ADDENDUM NO. 1

Roof Replacement Project
Facility Located At:
269 7th Avenue
Hanover, Ontario

Project No. 32224
May 22, 2206
Page 1

ROOF PLAN - ADDENDUM #1

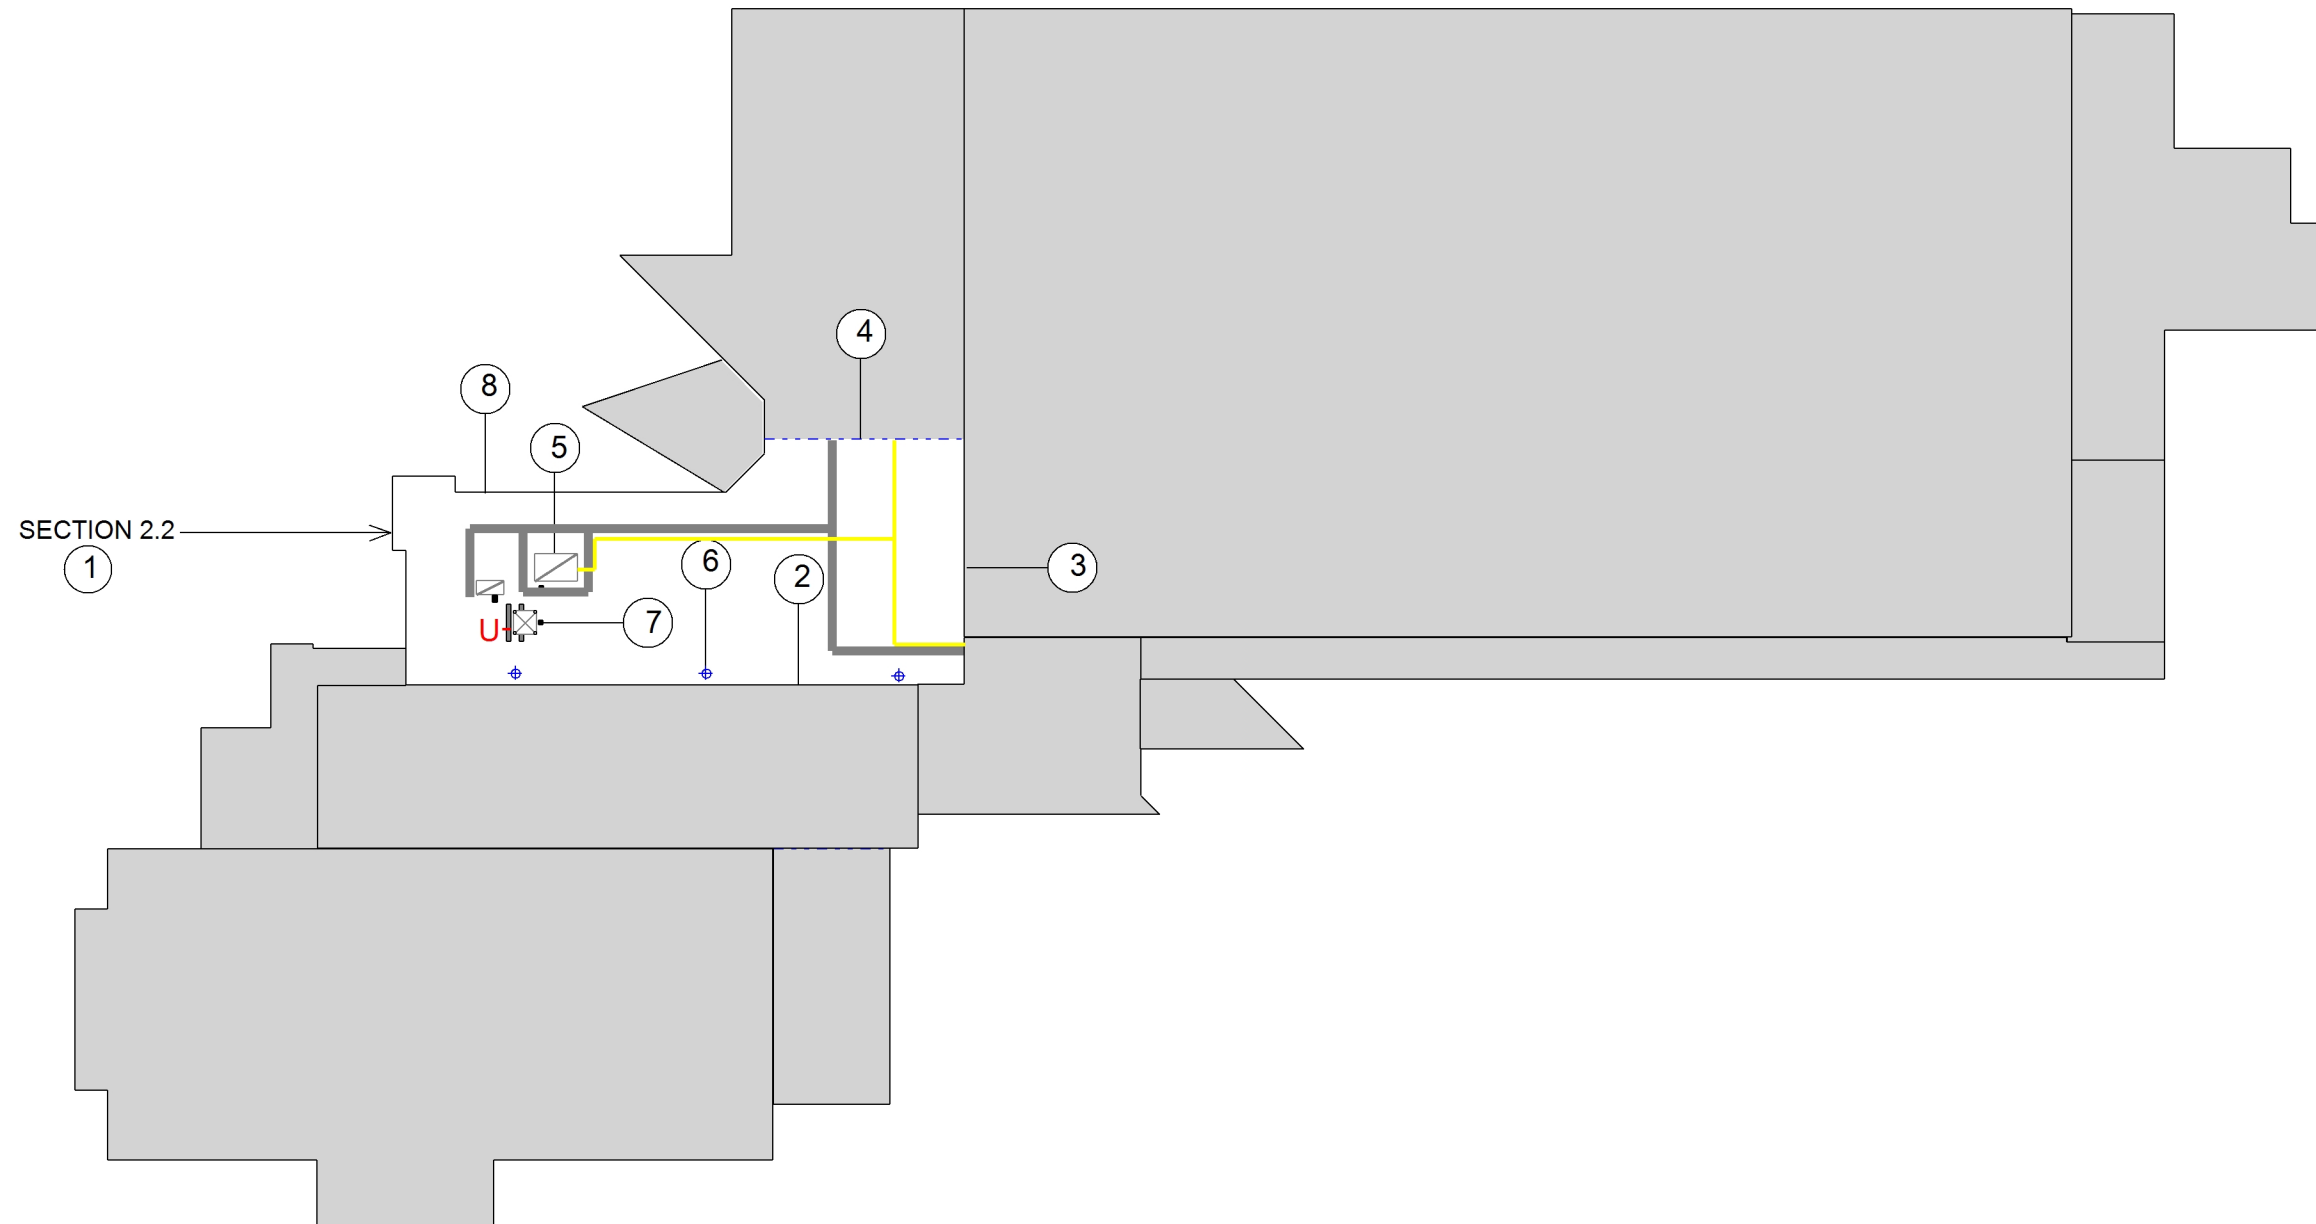
2. Replace Roof Plan – dated May 2026 with Roof Plan – Addendum #1 dated May 22, 2026 (1 page attached).

PERIMETER EAVE DETAIL #2

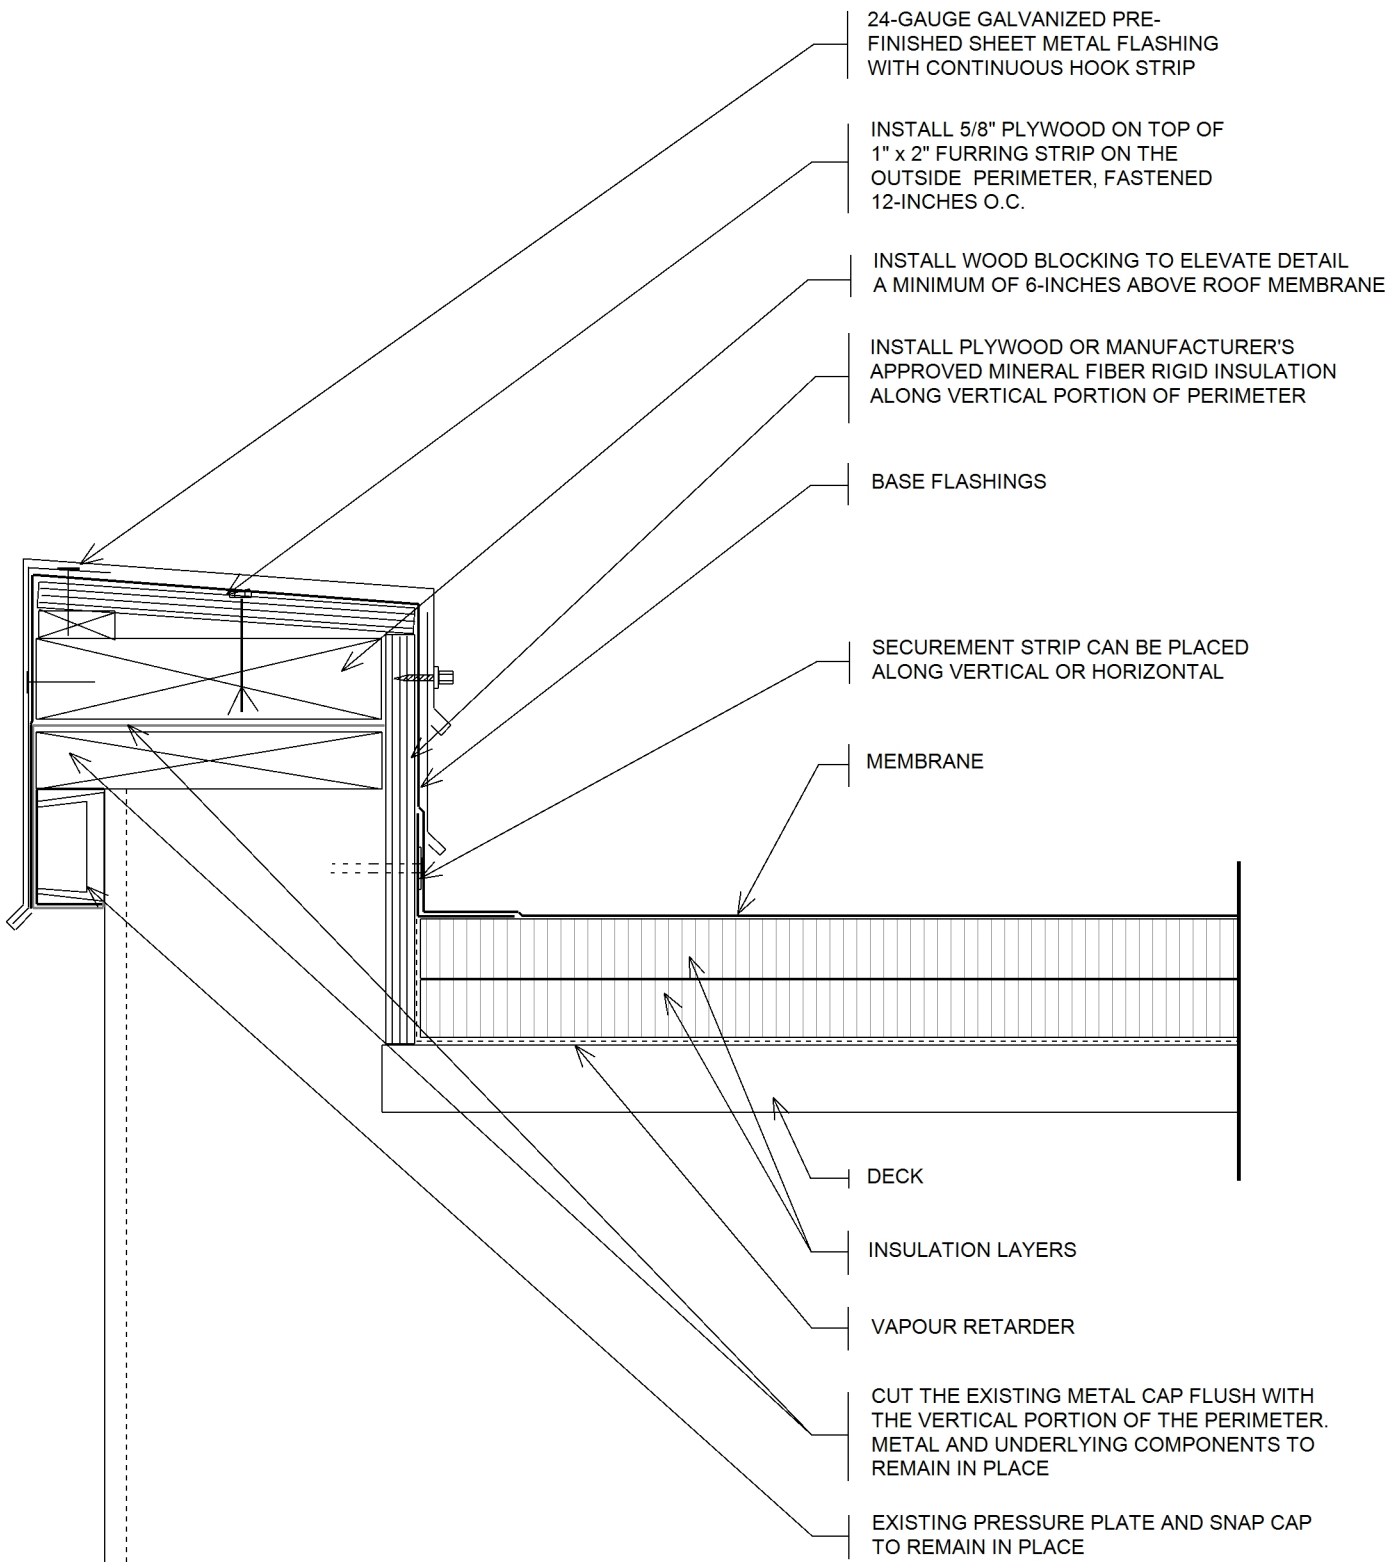
3. Add Detail Drawing #8 - Perimeter Eave Detail #2 (1 page attached).
